E5071B-17

SERVICE NOTE

E5071B - ENA Series Network Analyzer, 300 kHz to 8.5 GHz

"To strengthen the front USB receptacle, add USB receptacle retention plate"

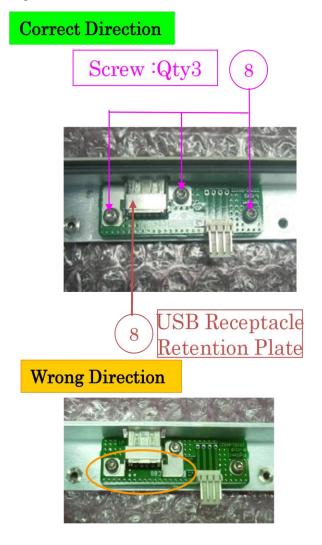
In case the front USB receptacle (E5070-66533) becomes loose, add USB receptacle retention plate (E5062-04003) to strengthen the front USB receptacle.

- e5070bse3007
- 1. Remove three pieces of screws. (See Reference Designator #8 of Figure 5-31 and Table 5-31 in the service manual)
- 2. Add USB receptacle retention plate.
- 3. Add the removed screws (See Reference Designator #8 of Figure 5-31 and Table 5-31 in the service manual) with 9 in-lb torque driver/T10 bit

Note: Pay attention to the direction of the USB receptacle retention plate.
